Access Compliance Report

Public Rights-of-Way

(Curb Ramps)

Intersection ID: 27556	Main Street: LEDERER_AV	Cross Street: QUEARY_CT	Location: NE
ADA ID: 0D43B839FDA9	Ramp Type: Perp	Initial Pass/Fail: Fail	Overall Compliance: No
Severity Score: 12.5			
Codes/Mitigation Info/Possible Solution		Field Measurements/Component Compliance

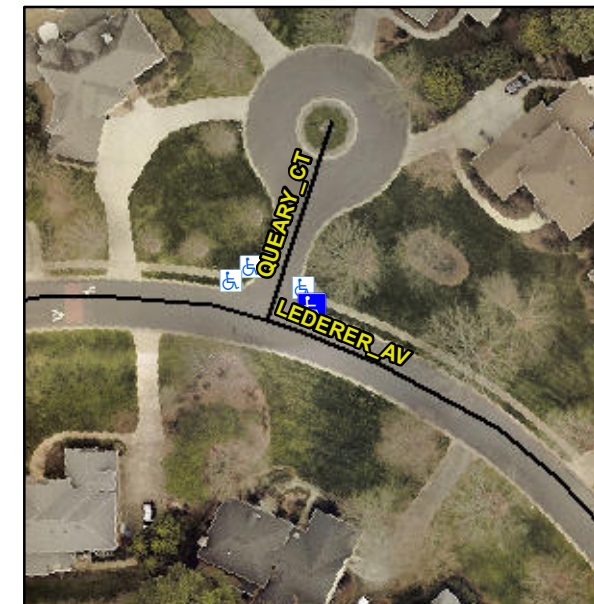
R304.5.3

Compliance	Description	Data	Compliance	Description	Data
N/A	Ramp Length (in)	34.5	Yes	Ramp Slope (%)	7.7
Yes	Ramp Width (in)	48.0	No	Ramp XSlope (%)	5.4
N/A	Flare Type LT	N/A	N/A	Flare Type RT	N/A
N/A	Flare Slope LT (%)	N/A	N/A	Flare Slope RT (%)	N/A
N/A	Flare Traversable LT?	N/A	N/A	Flare Traversable RT?	N/A
N/A	Landing Length (in)	N/A	N/A	DWS Provided?	N/A
N/A	Landing Width (in)	N/A	N/A	DWS Contrast?	N/A
N/A	Landing Slope (%)	N/A	N/A	DWS Length (in)	N/A
N/A	Landing X Slope (%)	N/A	N/A	DWS Full Width?	N/A
N/A	Landing Curb? (Y/N)	N/A	N/A	DWS Offset (in)	N/A
N/A	Shared Landing?	N/A			
N/A	Gutter Ponding?	N/A	N/A	Gutter Slope (%)	N/A
N/A	Gutter Lip Ht (in)	N/A	N/A	Gutter X Slope (%)	N/A
N/A	Painted X Walk1?	No	N/A	Painted X Walk2?	N/A
	X Walk 1 Direction	To SW		X Walk 2 Direction	N/A
N/A	X Walk 1 Width (in)	N/A	N/A	X Walk 2 Width (in)	N/A
	X Walk 1 Slope (%)	3.3		X Walk 2 Slope (%)	N/A
	X Walk 1 X Slope (%)	1.3		X Walk 2 X Slope (%)	N/A

Remove & Replace Entire Ramp.
